MEMORANDUM

East Gude Drive Phase I Transportation Facility Planning Study

Crabbs Branch Way to Southlawn Lane Project Prospectus Recommendations

RECOMMENDATION: Transmit the following comments to the Montgomery County Department of Transportation (MCDOT):

Figure ES-2a. Alternative 3: Enhanced Master Plan, Recommended Alternative. Proposed typical roadway along East Gude Drive at Section A-A, approximately 1,000' east of Calhoun Drive.

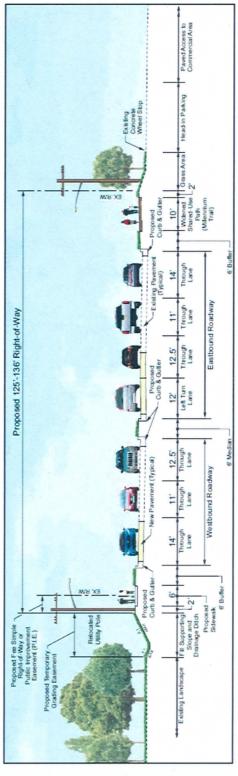
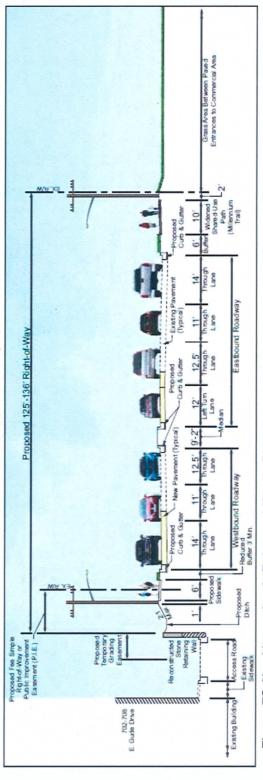
- 1. The East Gude Drive Transportation Facility Planning Study should proceed to Phase II of the Facility Planning process to develop a detailed design of the Project Prospectus-recommended Alternative 3 Enhanced Master Plan Alternative.

- 2. The design for the East Gude Drive project between Crabbs Branch Way and Southlawn Lane should include the following changes:
 - a. Provide a marked crosswalk and median refuge on the east leg of East Gude Drive at the Crabbs Branch Way/Cecil Street intersection to improve safety and access to the bus stops on either side of East Gude Drive. If a marked crosswalk cannot be provided, signs should be placed to prohibit the crossing and the bus stops should be moved to a location where patrons can safely and easily access them from the opposite side of the street.

- b. Provide dual directional handicap ramps at all intersections within the project limits.
 - c. Provide pedestrian refuge medians at intersection crosswalks by extending the median beyond the crosswalk with a depressed median crossing.

- d. Provide a marked crosswalk with a median refuge between the bus stops at approximately Station 47+75 on East Gude Drive.
 - e. Provide lighting at all intersections and marked mid-block crosswalks within the project limits to American Association of State Highway and Transportation Officials (AASHTO) standards.

- f. Integrate street trees into the proposed alternative, including the median, to improve the character of East Gude Drive.
- 3. Continue to coordinate with planning staff on the Master Plan of Highways update in regard to the inclusion of a six-lane divided cross-section along the entire segment of East Gude Drive between Norbeck Road and Rockville Pike.
